**ސަލާމަތުގެ ޖަލްޞާޔާގެ ޖަލްޞާޔާގެ ޖަލްޞާޔާ**

މާލdives ސަރުކާރުގެ ގެޒެޓް ގައި ބަޔާންކުރި ޖަލްޞާޔާގެ ޖަލްޞާޔާގެ ޖަލްޞާޔާ	ޖަލްޞާޔާގެ ޖަލްޞާޔާ:
(IUL)266-PR/266/2025/25	ޖަލްޞާޔާގެ ޖަލްޞާޔާ:
05 ޖުލައި 2025	ޖަލްޞާޔާގެ ޖަލްޞާޔާ:

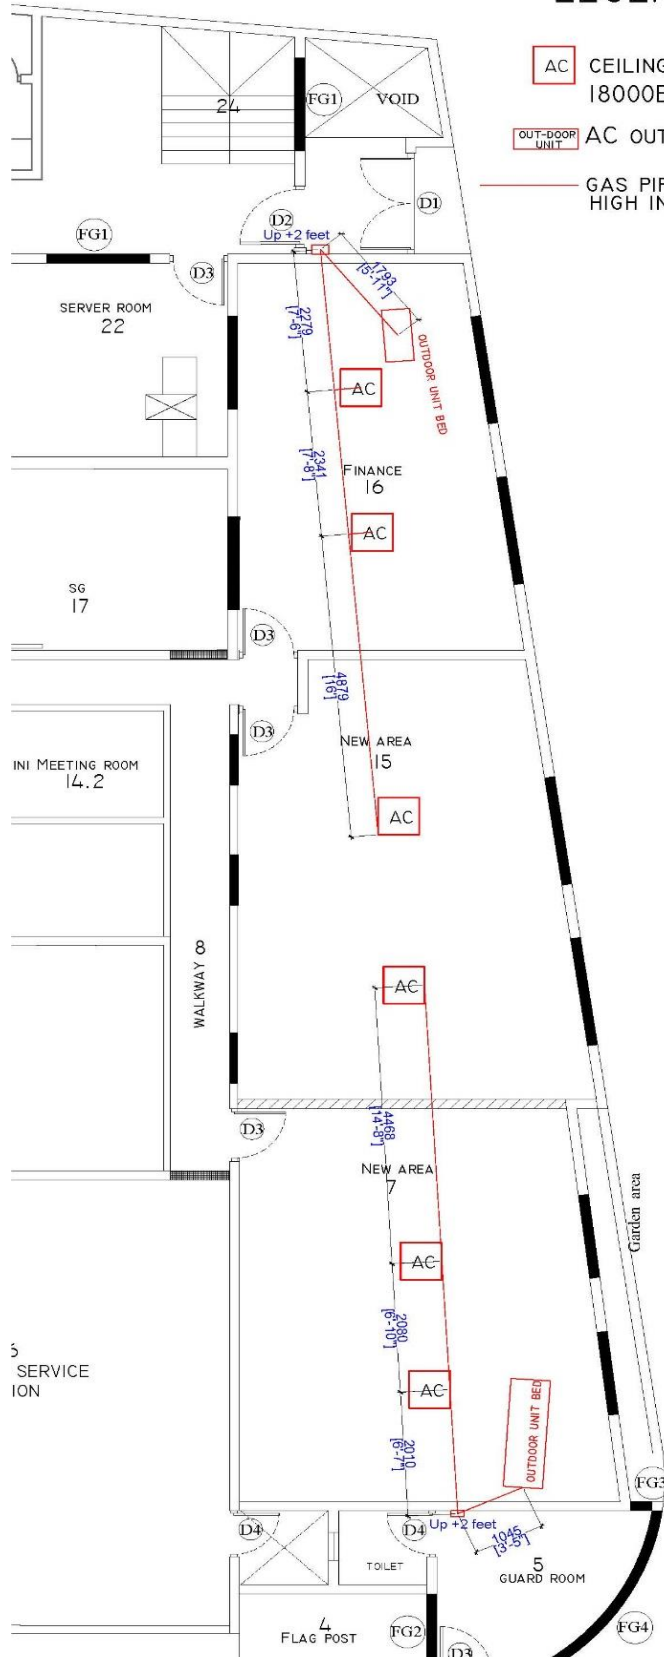
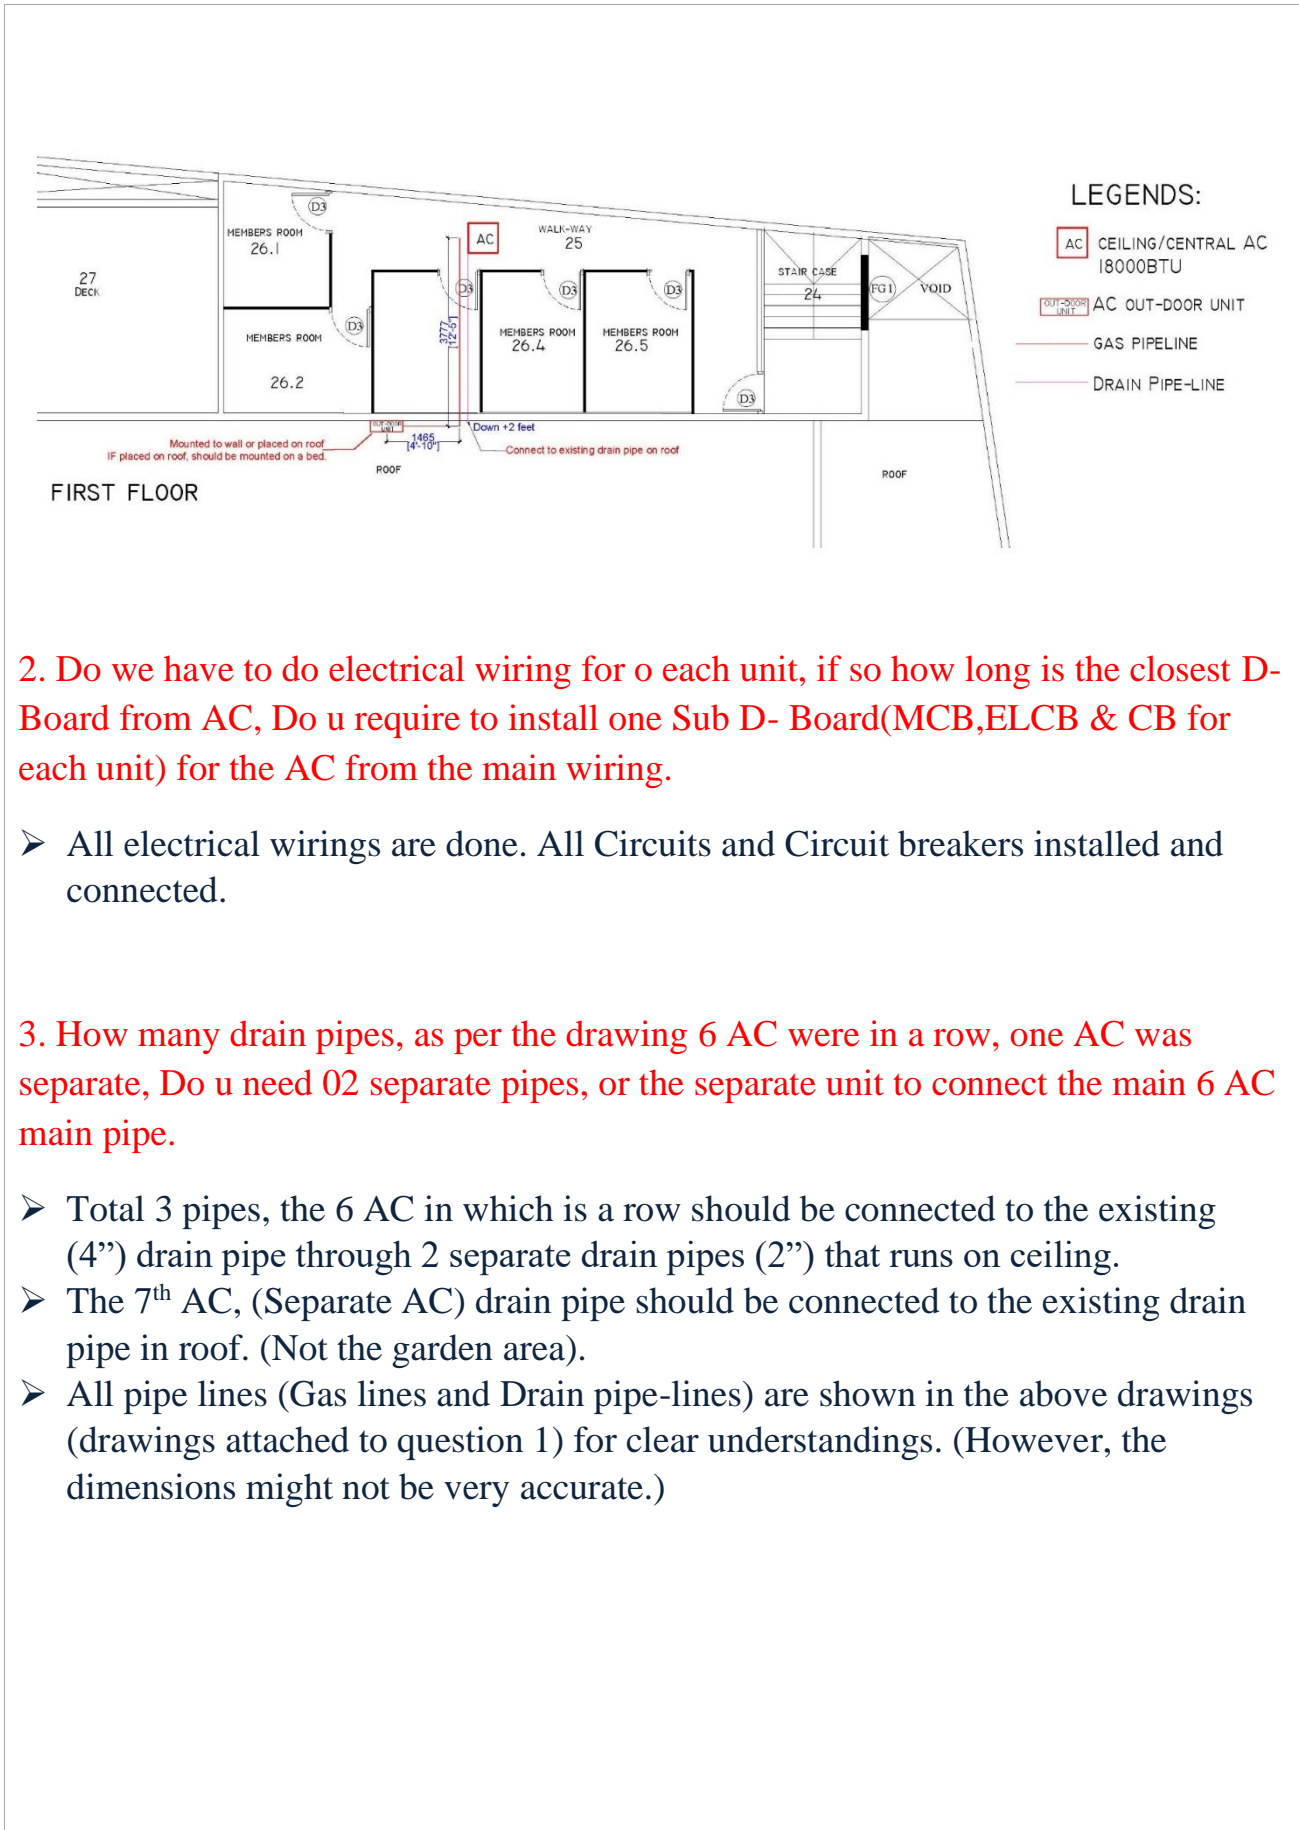
**1. Approx distance from indoor unit to outdoor unit for each.**

3. How many drain pipes, as per the drawing 6 AC were in a row, one AC was separate, Do u need 02 separate pipes, or the separate unit to connect the main 6 AC main pipe.

- All pipe lines (Gas lines and Drain pipe-lines) are shown in the drawings for clear understandings. (However, the dimensions might not be very accurate.

- Total 3 pipes, the 6 AC in which is a row should be connected to the existing (4") drain pipe through 2 separate drain pipes (2") that runs on ceiling.
- The 7<sup>th</sup> AC, (Separate AC) drain pipe should be connected to the existing drain pipe in roof. (Not the garden area).
- All pipe lines (Gas lines and Drain pipe-lines) are shown in the above drawings (drawings attached to question 1) for clear understandings. (However, the dimensions might not be very accurate.)
